**LOT 10, 777 SOUTH WESTERN HIGHWAY, BYFORD – PROPOSED  
WAREHOUSE (SELF STORAGE FACILITY)**

**Form 1 – Responsible Authority Report**  
(Regulation 12)

**Figure 2 - Initial Proposal Site Plan**

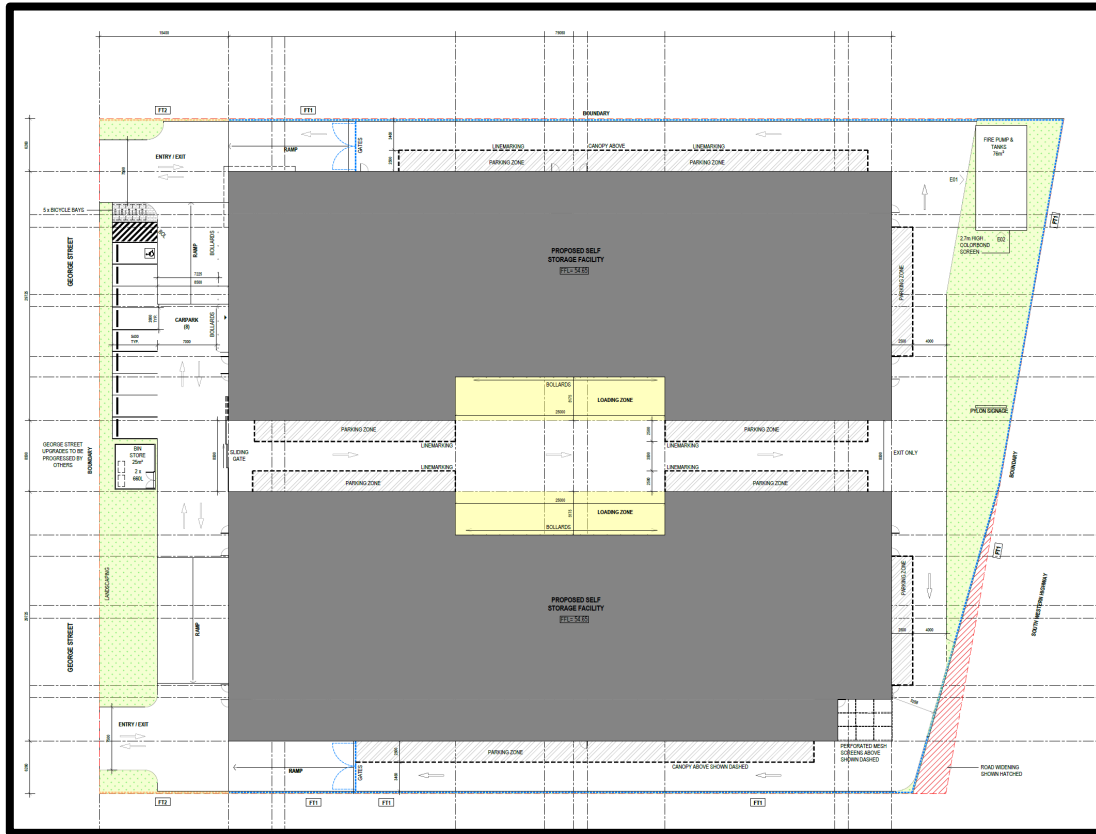
After initial consultation, the Shire raised a number of points of concern pertaining to aspects of the design that did not comply with the planning framework. These were specifically:

- The proposed development not considered to represent a form of physical works that protect current amenity, nor align with the intended future amenity for the service commercial zone, as documented under Local Planning Scheme 3 and the Byford Townsite Local Development Plan;

- The proposed development is not considered to provide sufficient layout and configuration to encompass the minimum landscaping required, which is necessary to help moderate the physical form of development especially as viewed from public areas;

- The proposed development is not considered to represent suitable design of the built environment, by way of its height, scale, bulk, materials and colours.

The applicant, in response, has provided revised plans. The revised development consists of development in the following manner:

- Modify the form of the development from a vertical multi-storey building into a horizontal single storey layout. The reduction in height creates a particularly less imposing built form, and more in keeping with the low scale development forms in Byford that connect with landscape.

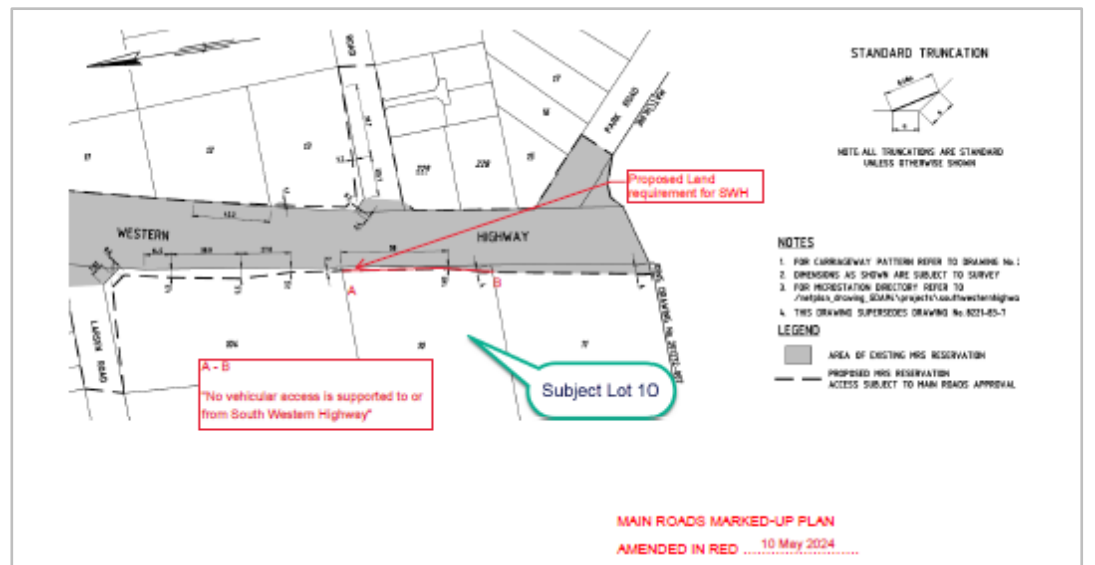
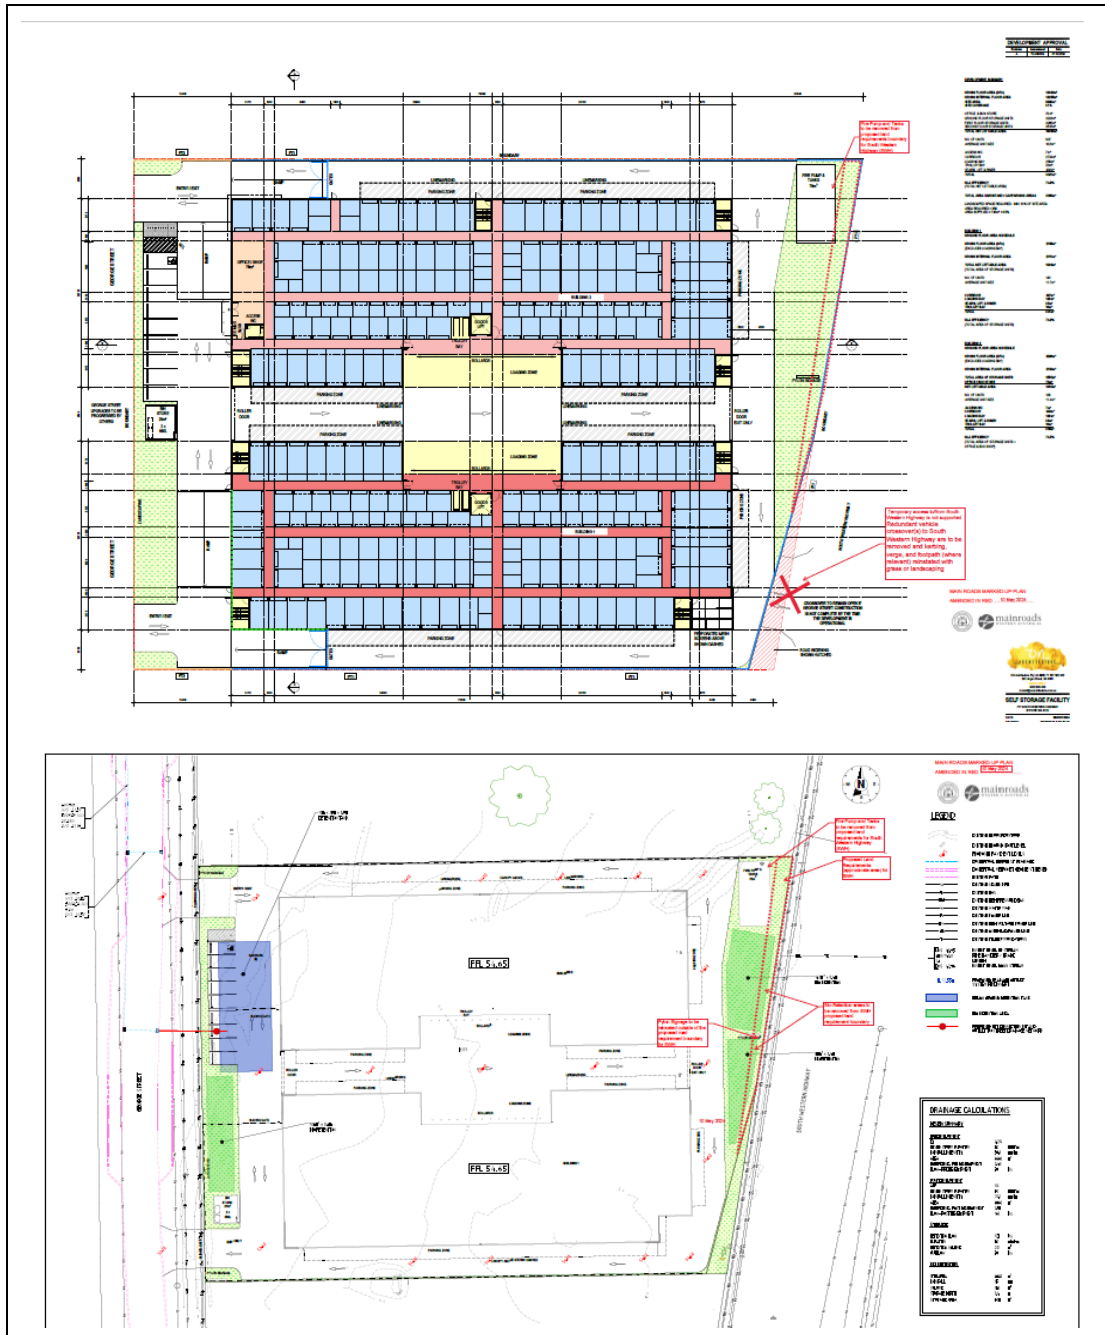
1. Prior to the issue of building approval, George Street must be constructed enable access the subject lot. George Street shall be constructed to the Shire's requirements.
2. No vehicular access to South West Highway is approved. Gates and crossover must be deleted from the approved plans (see marked up red plans for details).

3. No part of the development, other than approved landscaping is to be located within the proposed land requirement for South Western Highway as detailed in the attached Land Protection Plan 201232-0006 (extract). The Fire Pump & Tank, Bio Retention and any associated infrastructure services as depicted in the

Stormwater Management Plan (23-11-135/400), dated February 2024 is to be removed from the future road reserve. See marked up red plans for details.

No form of the development should encroach upon the identified land requirement.

5. Stormwater shall not be discharged to the South Western Highway Road Reserve

Supported. The Shire will recommend conditions to MODAP requiring the application to be constructed upon the delivery of the George Street upgrades being finalised. The Shire will also recommend conditions for any works to be omitted from the marked plans where MRWA will be requiring future land for the upgrade of South Western Highway.

**Figure 14 - Proposed Storm Water Retention Areas**

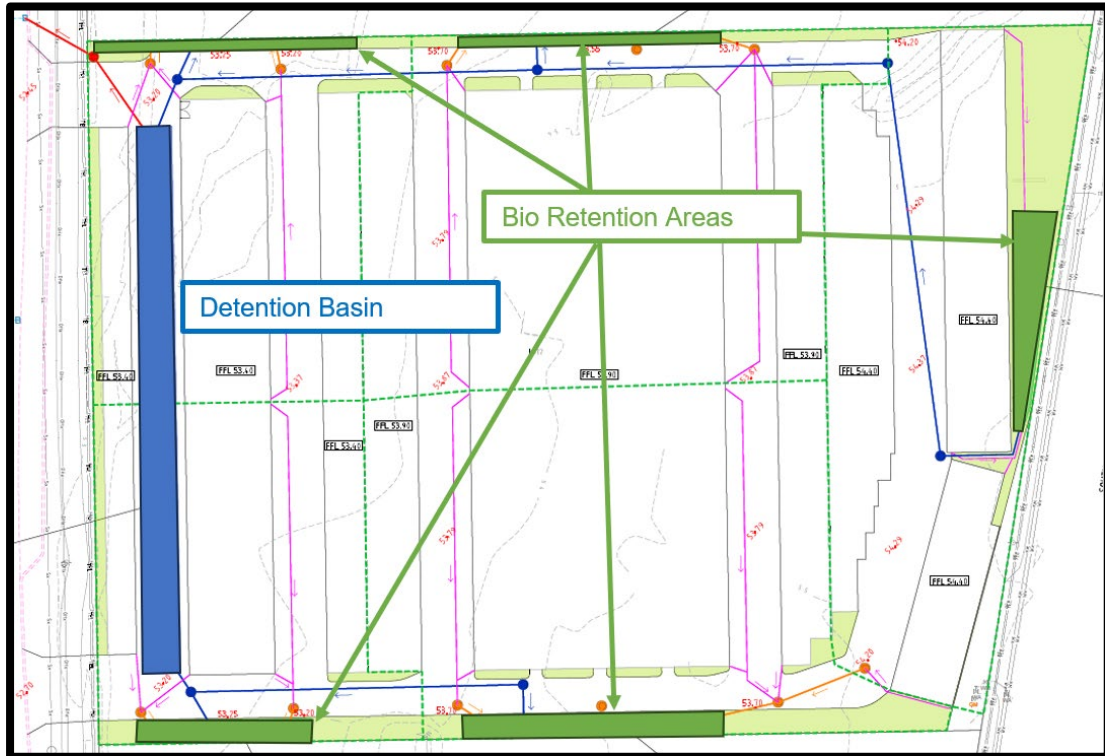
Officers consider that further details should be provided, should the application be approved, showing specifically how discharge rates of stormwater do not exceed predevelopment flows, or the adopted DWMS for Byford. Further details must also demonstrate that the storage requirement for rainfall events can cater for a 1% AEP (annual exceedance probability) and ensure that the ground floor units, car parking area and traffic circulation areas do not flood.

- b. Prior to the lodgement of a Building Permit, a revised Stormwater Management Plan must be submitted to and approved by the Shire of Serpentine Jarrahdale. The Plan must demonstrate:

- i. That offsite discharge rates of stormwater do not exceed predevelopment flow rates or the maximum levels set under the Byford DWMS;
- ii. That the storage requirement for rainfall events can cater for a 1% AEP (annual exceedance probability) while ensuring that the ground floor units, car parking area and traffic circulation areas do not flood.

**Figure 19 - George Street Design Parking Conflict**

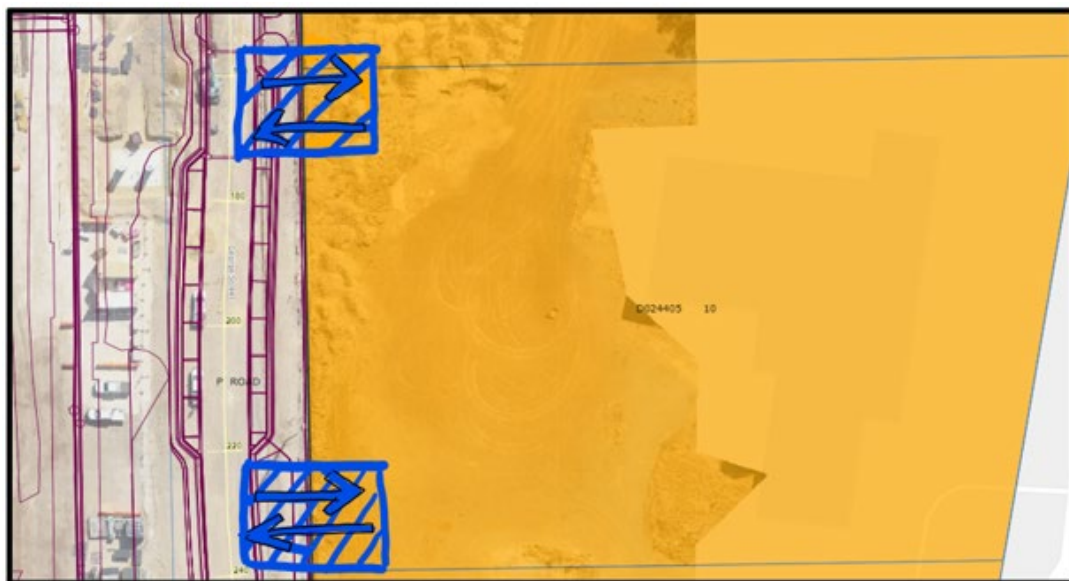
The Public Transport Authority (PTA) initially raised concerns in relation to the location of the northernmost crossover due to a conflict with parking bays proposed on George Street. The PTA suggested that the development be limited to the southern crossover only. The proposed northern crossover and the location of the future PTA parking bays at this time are shown following:

PTA has subsequently reviewed and revised the George Street design details. Confirmation has been received from the PTA that there will no longer be a conflict

between the proposed access and the future parking bays. Given MRWA's position not to support a crossover onto Southwestern Highway, the provision of a second crossover from George Street is integral to the development being able to achieve safe egress from the site. A condition is recommended for the applicant to provide detailed engineering drawings to the satisfaction of the Shire in liaison with PTA, MetConnx and the OMITD.

**Figure 21 - MRWA objection to the temporary crossover**

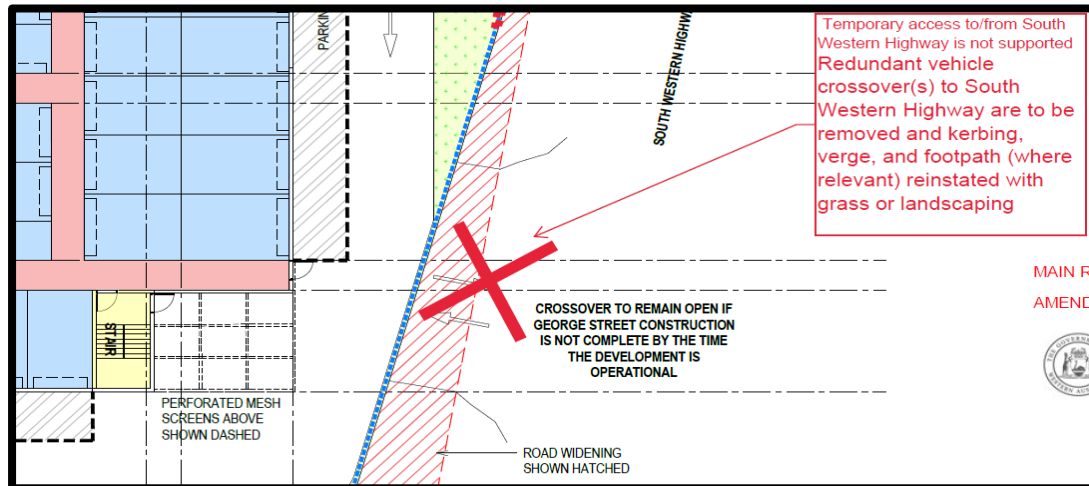
MRWA do not support the use of the crossover on South Western Highway and have proposed a condition requiring its removal. Given the traffic volumes on South Western Highway, its function as a Primary Regional Road and the comments received by MRWA, Officers also do not support this aspect of the proposal.

- l. No vehicular access to South West Highway is approved for the operation of the development. Gates and crossover must be deleted from the approved plans.
